Access Compliance Report

Public Rights-of-Way

(Curb Ramps)

Intersection ID: 20264	Main Street: DINGESS_RD	Cross Street: MEADHAVEN_DR	Location: NW
ADA ID: 87DDF849E619	Ramp Type: PerpDiag	Initial Pass/Fail: Fail	Overall Compliance: No
Severity Score: 22.5			
Codes/Mitigation Info/Possible Solution		Field Measurements/Component Compliance

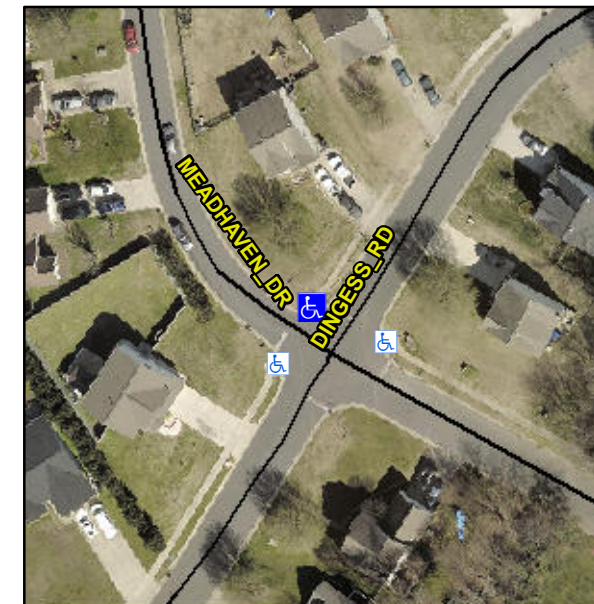
R304.5.1, R304.2.2, R304.5.3

Compliance	Description	Data	Compliance	Description	Data
N/A	Ramp Length (in)	45.0	No	Ramp Slope (%)	11.3
No	Ramp Width (in)	41.0	No	Ramp XSlope (%)	2.7
N/A	Flare Type LT	N/A	N/A	Flare Type RT	N/A
N/A	Flare Slope LT (%)	N/A	N/A	Flare Slope RT (%)	N/A
N/A	Flare Traversable LT?	N/A	N/A	Flare Traversable RT?	N/A
N/A	Landing Length (in)	N/A	N/A	DWS Provided?	N/A
N/A	Landing Width (in)	N/A	N/A	DWS Contrast?	N/A
N/A	Landing Slope (%)	N/A	N/A	DWS Length (in)	N/A
N/A	Landing X Slope (%)	N/A	N/A	DWS Full Width?	N/A
N/A	Landing Curb? (Y/N)	N/A	N/A	DWS Offset (in)	N/A
N/A	Shared Landing?	N/A			
N/A	Gutter Ponding?	N/A	N/A	Gutter Slope (%)	N/A
N/A	Gutter Lip Ht (in)	N/A	N/A	Gutter X Slope (%)	N/A
N/A	Painted X Walk1?	No	N/A	Painted X Walk2?	No
	X Walk 1 Direction	To SW		X Walk 2 Direction	To SE
N/A	X Walk 1 Width (in)	N/A	N/A	X Walk 2 Width (in)	N/A
	X Walk 1 Slope (%)	0.6		X Walk 2 Slope (%)	1.3
	X Walk 1 X Slope (%)	1.2		X Walk 2 X Slope (%)	0.1

Remove & Replace Curb Ramp With Two New Directional Ramps or Equivalent.
